AMENDED

SUNDRY NOTICES AND REPORTS ON WELLS

UTE INDIAN "B"

October 3, 1957

NEW MEXICO OIL CONSERVATION COMMISSION
Well Location and Acreage Dedication Plat

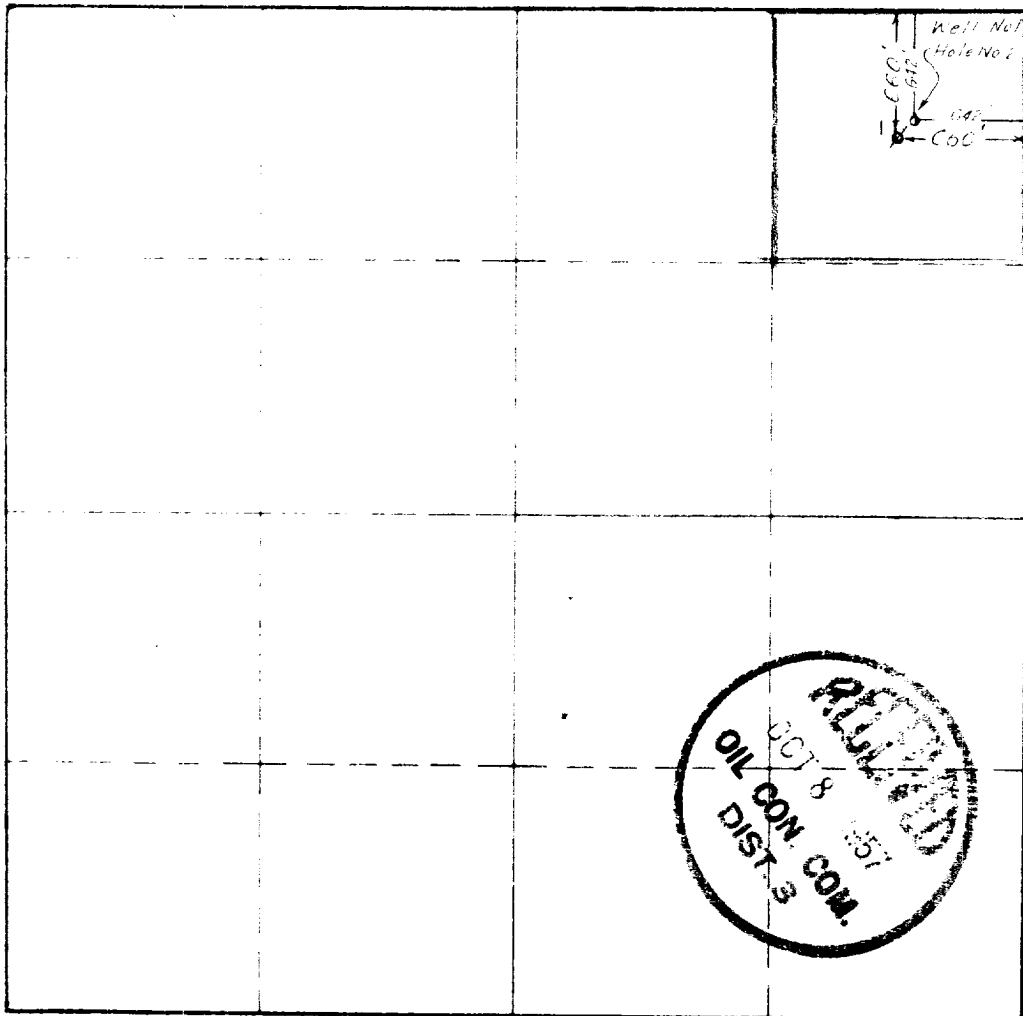
NOTE: This amended application filed to change the location of the well, since the original hole was lost and the rig skidded. We are attaching amended copies of our Form C-123 and the well number will be changed to read Ute Indian "B" Well #1-X.

Operator HUMBLE OIL & REFG CO Lease UTE MOUNTAIN TRIBE OF INDIANS "B"
Well No. 1 Unit Letter "A" Section 25 Township -31-N Range -15-W N.M.P.M.
Located 642 Feet From NORTH Line, 642 Feet From EAST Line
County SAN JUAN G. L. Elevation _____ Dedicated Acreage 40 Acres
Name of Producing Formation VERDE-GALLUP Pool VERDE-GALLUP
